Project	Steamboat Base Village Redevelopment	Date	07/23/2021
Project Location	Steamboat, Colorado	Architect's Project Number	03.7835.000
Owner/Client	Alterra Mountain Company / East West Partners	File	6BL This is page 1 of 2
To	Saunders Construction Inc.	Attention	Bryan Sculthorpe
Address	86 Inverness Place North		
City	Englewood	State	CO Zip Code 80112
Delivered via:	<input type="checkbox"/> Messenger <input type="checkbox"/> Hand carried <input type="checkbox"/> Facsimile <input type="checkbox"/> Express <input type="checkbox"/> Pick-up <input type="checkbox"/> E-mail Address <input type="checkbox"/> Mail <input type="checkbox"/> UPS <input checked="" type="checkbox"/> Website Address BIM360

Bulletin Number - BP3 Promenade - 06

Description of Changes

This bulletin addresses the following:
Landscape planters, site walls, associated grading
Telecom sheet updates for on mountain coordination

SITE
DETAILS
1A-L7-03

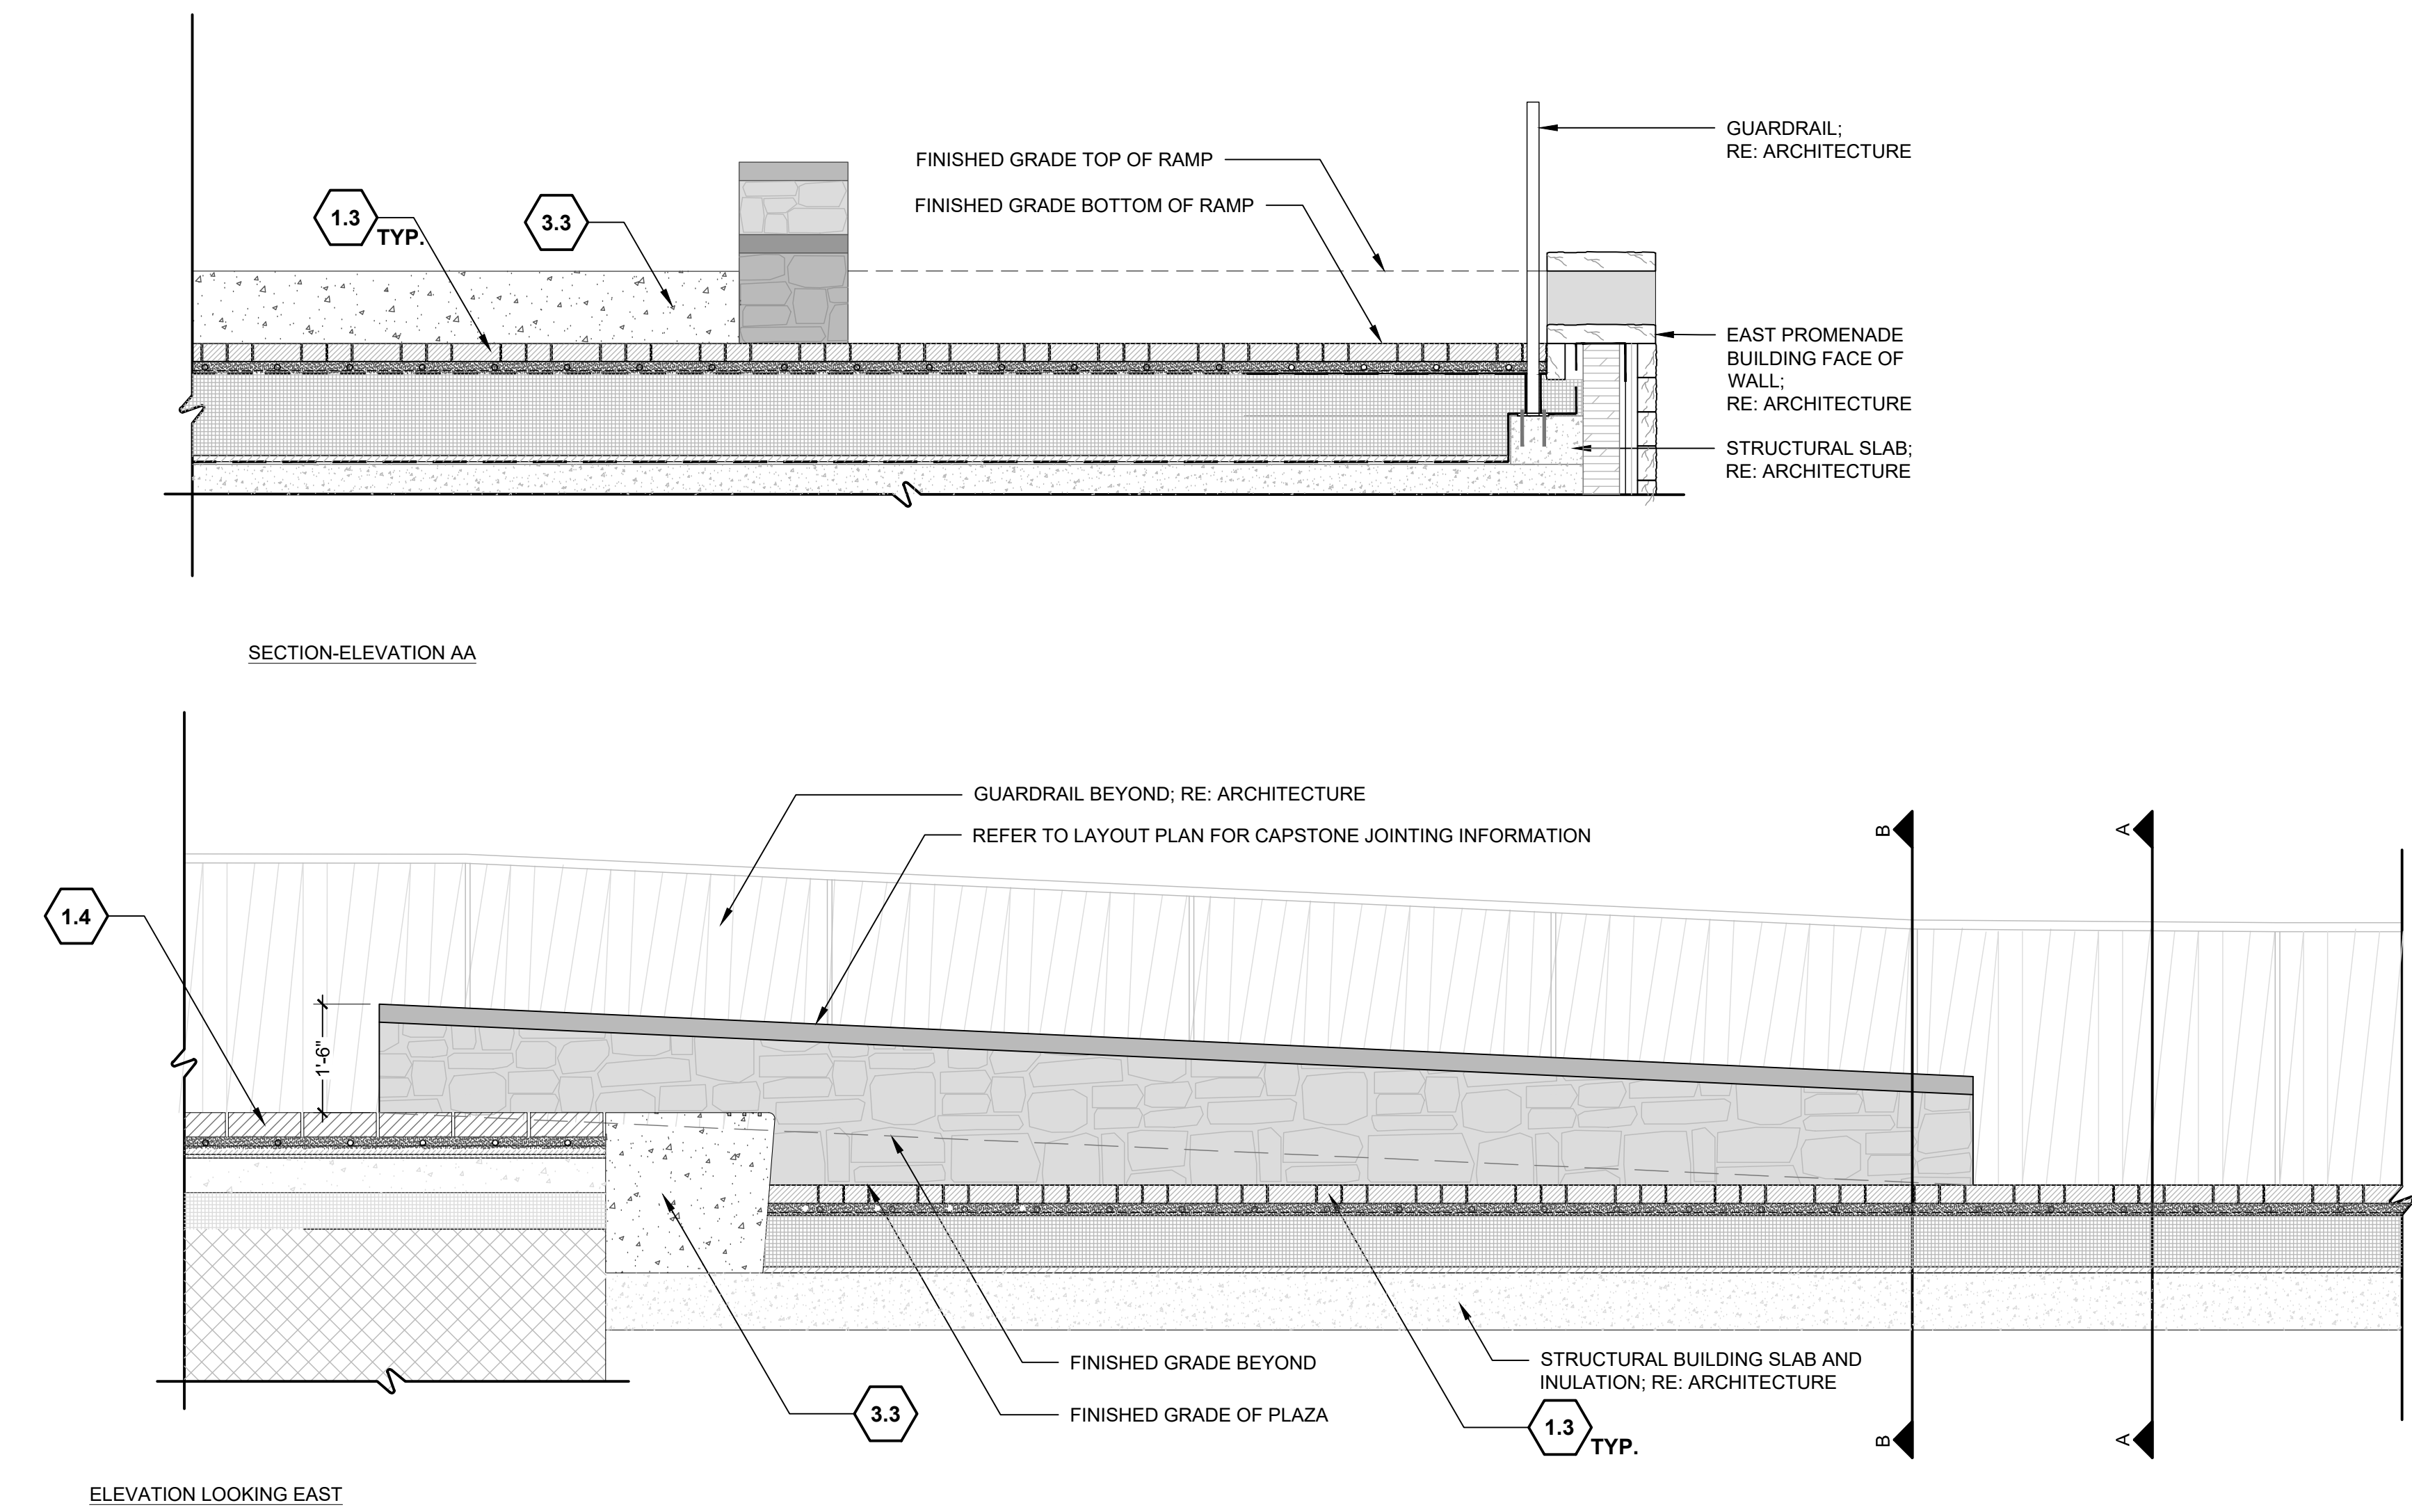
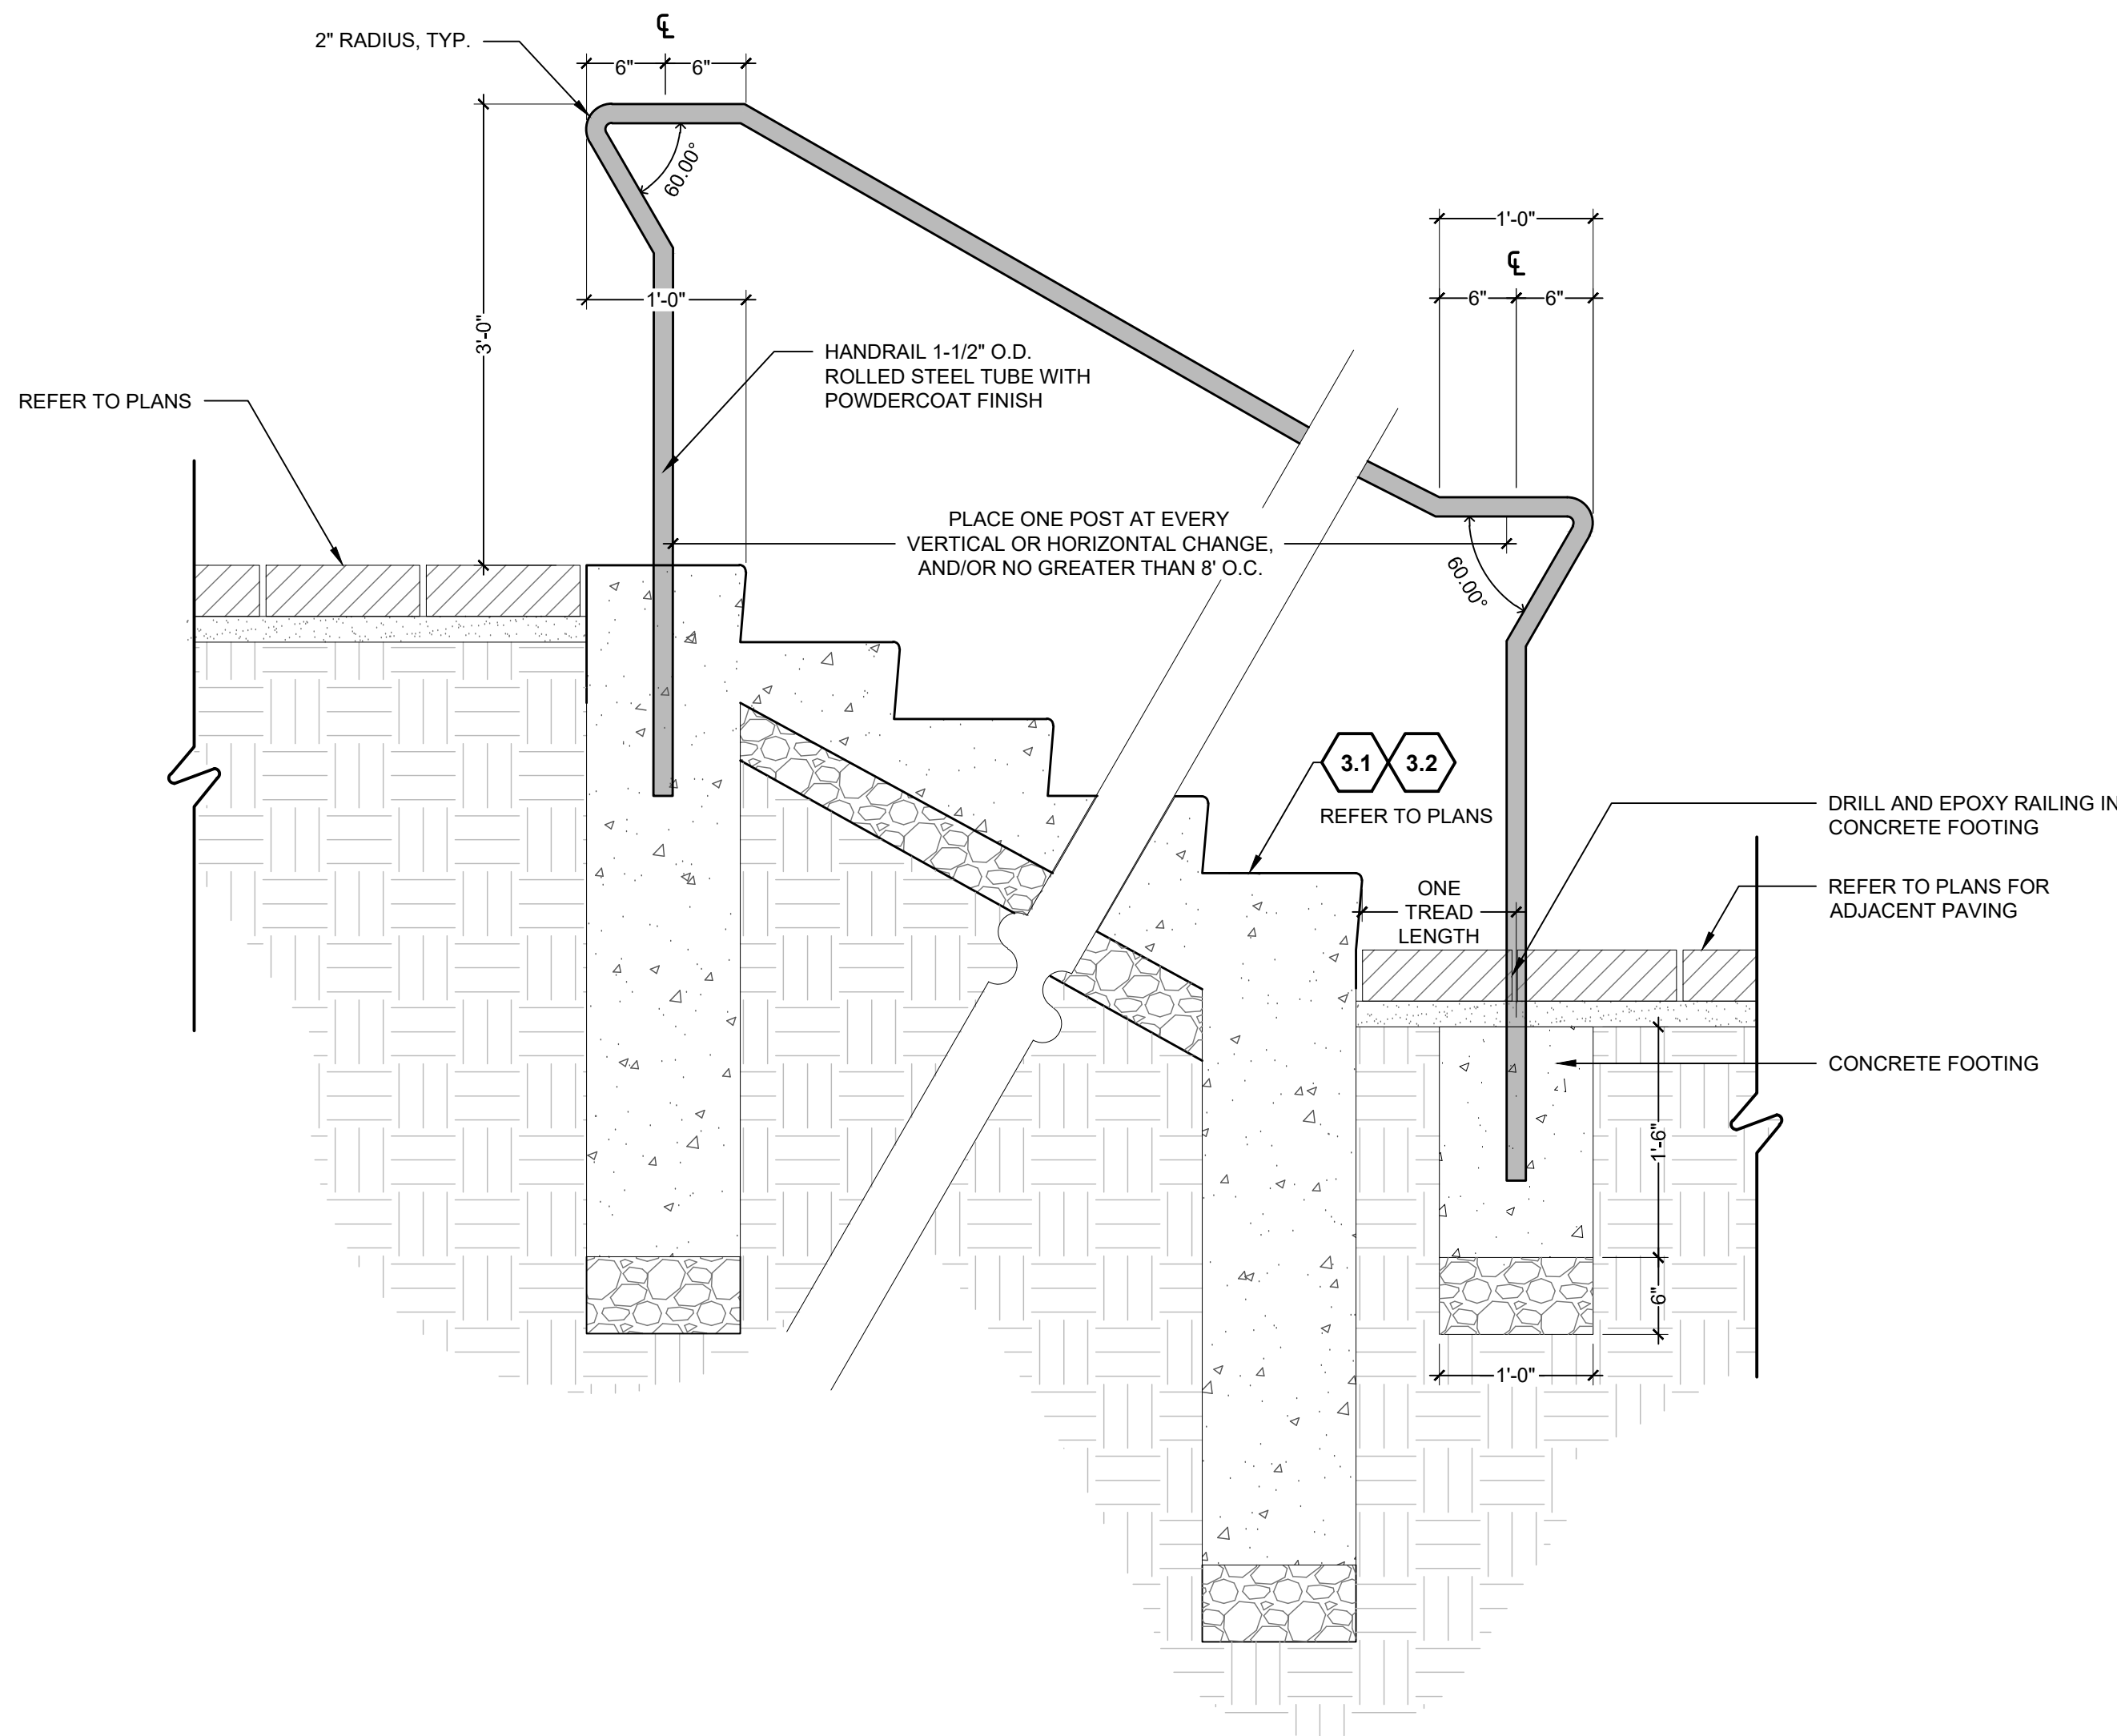
1A-L7-02 Site Details	Section 2 revised to include wall type 5.
1A-L7-03 Site Details	Sections 2 and 3 revised/added to show wall details type 3 and 4.
1A-L7-04 Site Details	Section/Elevation 1 title change to wall type 2.
1A-L7-08 Composite Sections	Elevation 2 added and elevation 3 revised to show relationship of southern promenade walls and transformer.
1A-L7-11 Site Details	New sheet showing wall types 5 and 6.
1A-L8-01 Planting Plan	Eastern tree removed from northeastern planter, shrubs and groundcovers reduced to accommodate new planter size.
1A-L8-02 Planting Plan	Trees, shrubs and added to fill larger planter at lower promenade level.
Irrigation Sheets:	
1A-IR-01 Irrigation Plan	Adjusted irrigation to match new planter geometries.
